Access Compliance Report

Public Rights-of-Way

Intersection ID: N/A	Main Street: KIRKWYND COMMONS DR	Cross Street: BRECKFIELD CT	Location: NW
ADA ID: CFC3A354F0D0	Ramp Type: PerpDiag	Initial Pass/Fail: Fail	Overall Compliance: No
Severity Score: 13.75			
Codes/Mitigation Info/Possible Solution		Field Measurements/Component Compliance

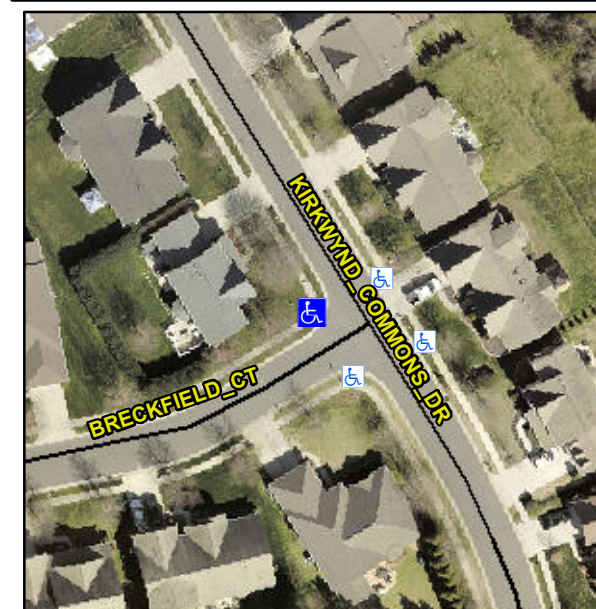
PROW/ADA:

R304.2.2, R304.5.3

Compliance	Description	Data	Compliance	Description	Data
N/A	Ramp Length (in)	48.0	No	Ramp Slope (%)	8.9
Yes	Ramp Width (in)	48.0	No	Ramp XSlope (%)	4.5
N/A	Flare Type LT	N/A	N/A	Flare Type RT	N/A
N/A	Flare Slope LT (%)	N/A	N/A	Flare Slope RT (%)	N/A
N/A	Flare Traversable LT?	N/A	N/A	Flare Traversable RT?	N/A
N/A	Landing Length (in)	N/A	N/A	DWS Provided?	N/A
N/A	Landing Width (in)	N/A	N/A	DWS Contrast?	N/A
N/A	Landing Slope (%)	N/A	N/A	DWS Length (in)	N/A
N/A	Landing X Slope (%)	N/A	N/A	DWS Full Width?	N/A
N/A	Landing Curb? (Y/N)	N/A	N/A	DWS Offset (in)	N/A
N/A	Shared Landing?	N/A			
N/A	Gutter Ponding?	N/A	N/A	Gutter Slope (%)	N/A
N/A	Gutter Lip Ht (in)	N/A	N/A	Gutter X Slope (%)	N/A
N/A	Painted X Walk1?	No	N/A	Painted X Walk2?	No
	X Walk 1 Direction	To SE		X Walk 2 Direction	To NE
N/A	X Walk 1 Width (in)	N/A	N/A	X Walk 2 Width (in)	N/A
	X Walk 1 Slope (%)	3.8		X Walk 2 Slope (%)	0.8
	X Walk 1 X Slope (%)	1.5		X Walk 2 X Slope (%)	1.9

N/A	Ramp inside XWalk1?	N/A	N/A	Ramp inside XWalk2?	N/A
	Road Slope (%)	3.1	N/A	Clear Space?	N/A
	Road X Slope (%)	0.8	N/A	Clear Space to XWalk (in)	N/A
N/A	Any Obstructions?	N/A	N/A	Storm Grate/Utility Hazard?	N/A
	Obstruction Type			Storm Grate/Utility Type	
		N/A			N/A
			Yes	Surface Condition? (G/P)	Good

Remove & Replace Curb Ramp With Two New Directional Ramps or Equivalent.
